**DOCUMENT - 2026-353T
INTERIOR RENOVATIONS FOR PEEL REGIONAL POLICE AT 180 DERRY
ROAD EAST, MISSISSAUGA
ADDENDUM NO 4**

ADD03

Electrical and Technology Addendum No. 03

Project: Emil V Kolb Center, Peel Regional Police Facility Renovation
(EXP Project Number MRK-25008051-A0)

1.1.1. E102 – PARTIAL SECOND FLOOR - POWER AND SYSTEMS - DEMO & NEW (included herein)

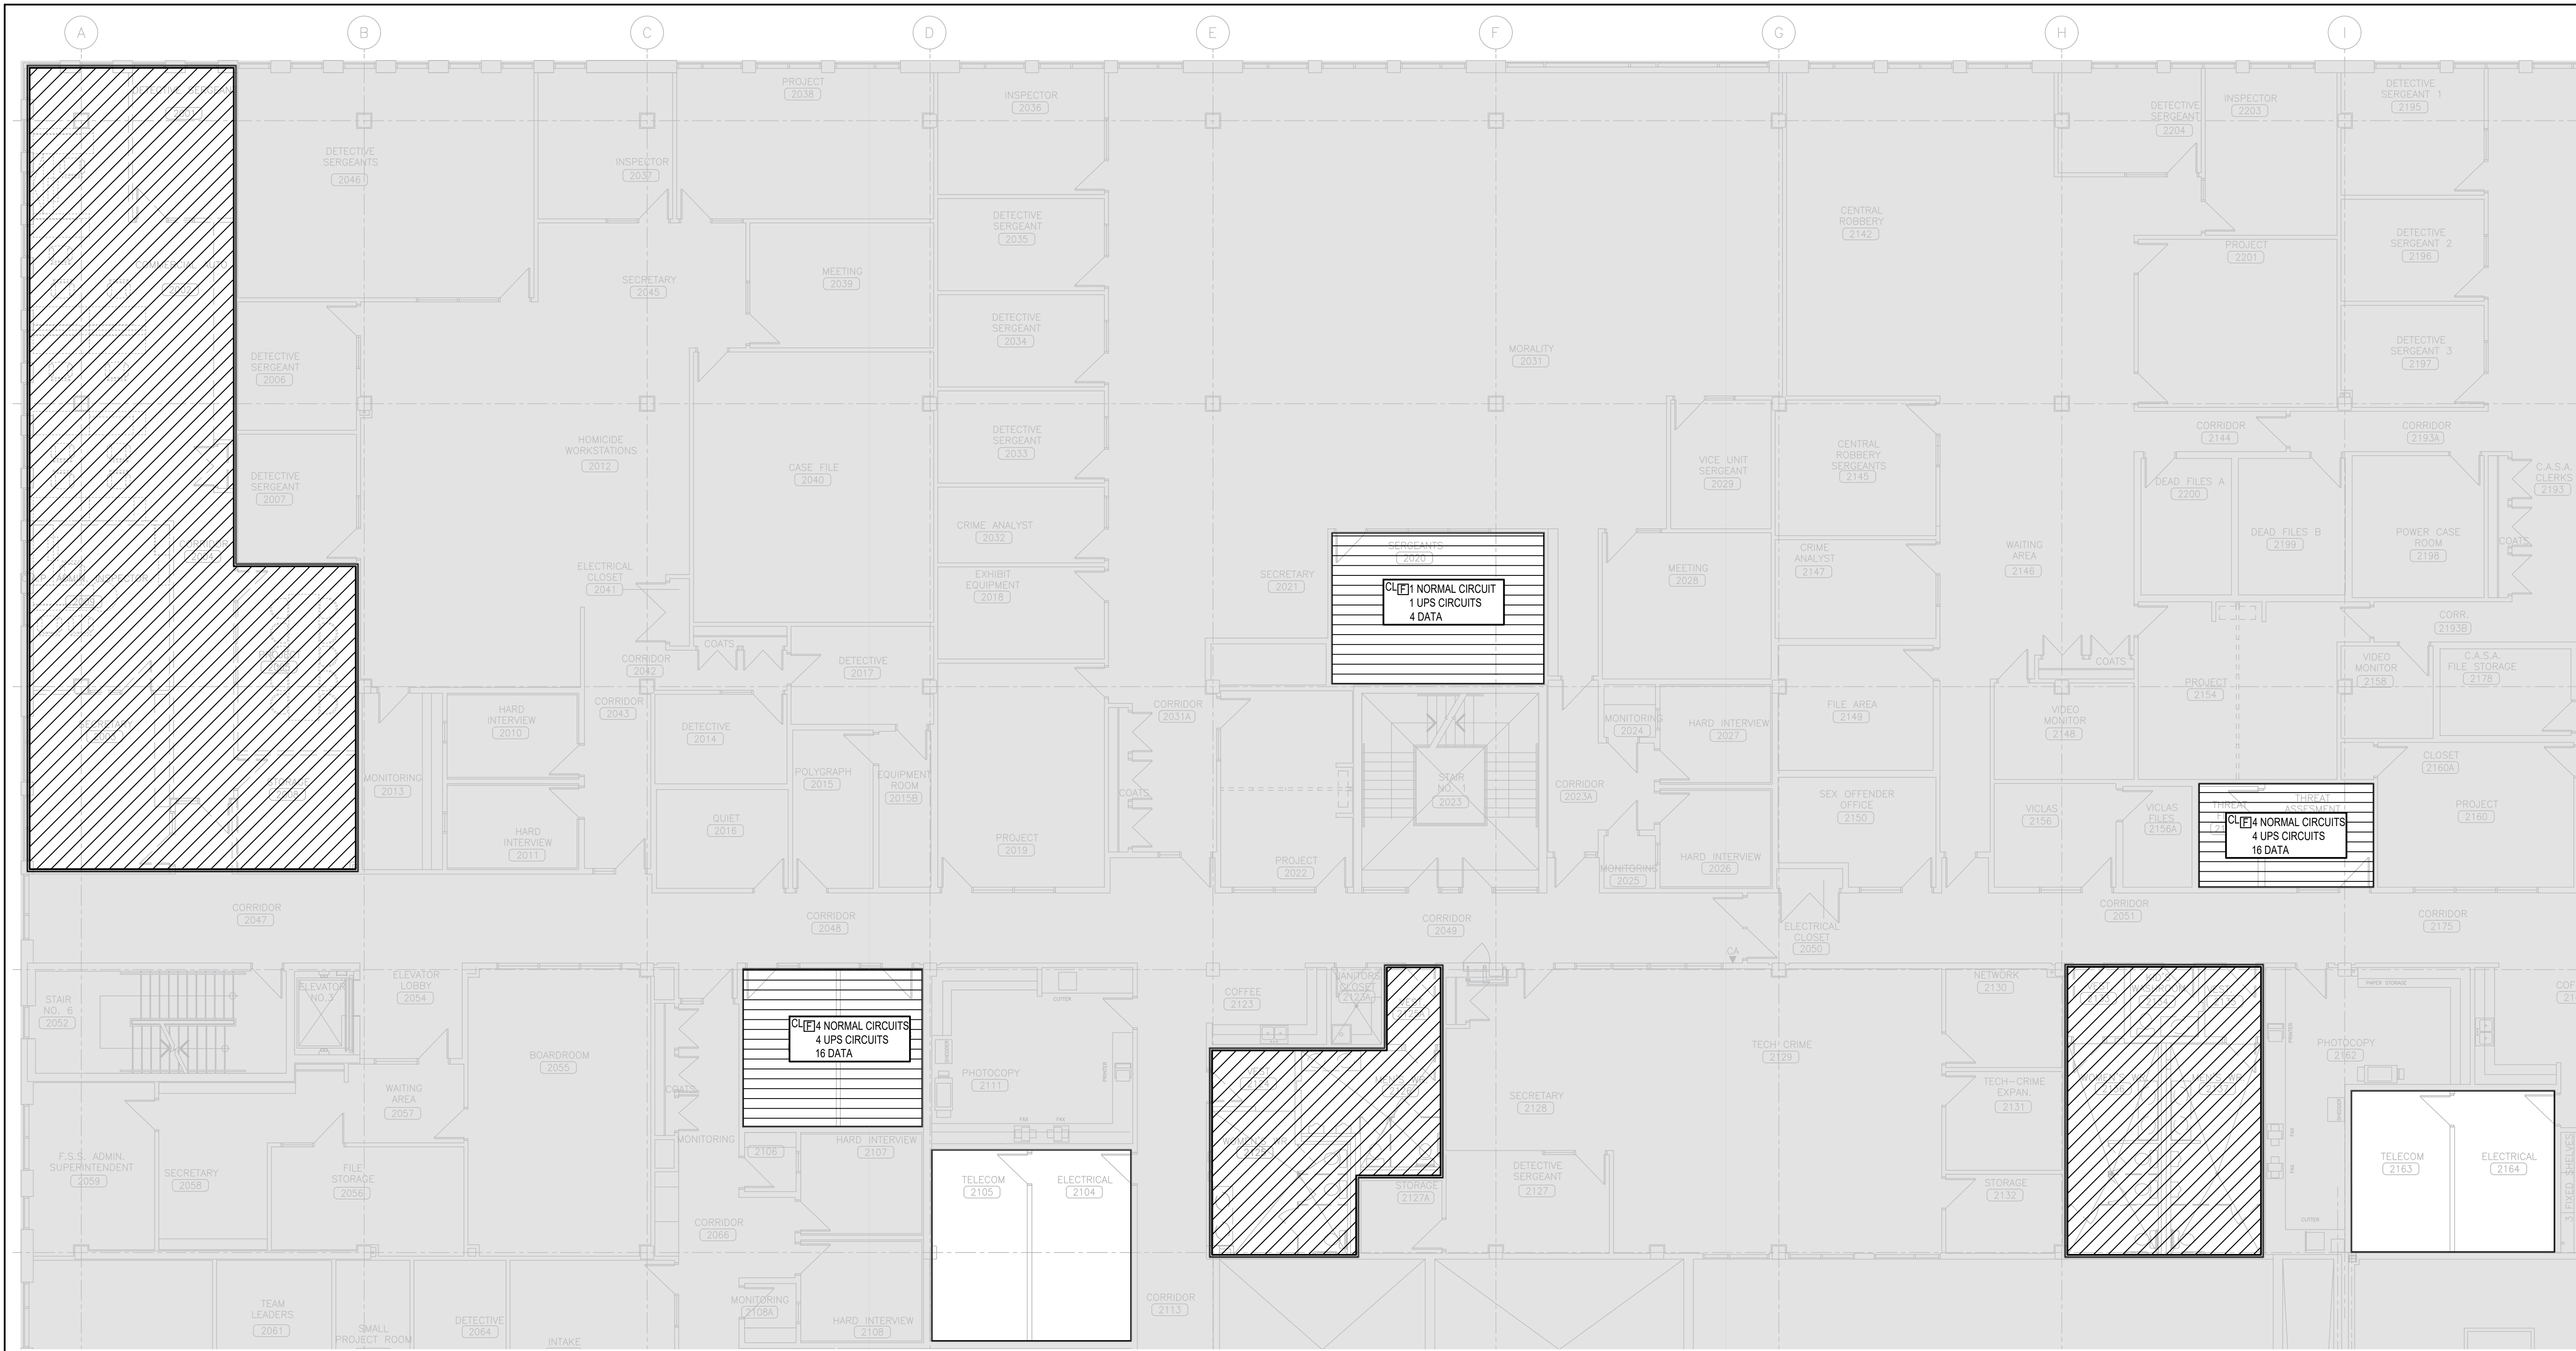
- .1 Revise layout to include existing equipment at Telecom 2163, as bubbled.
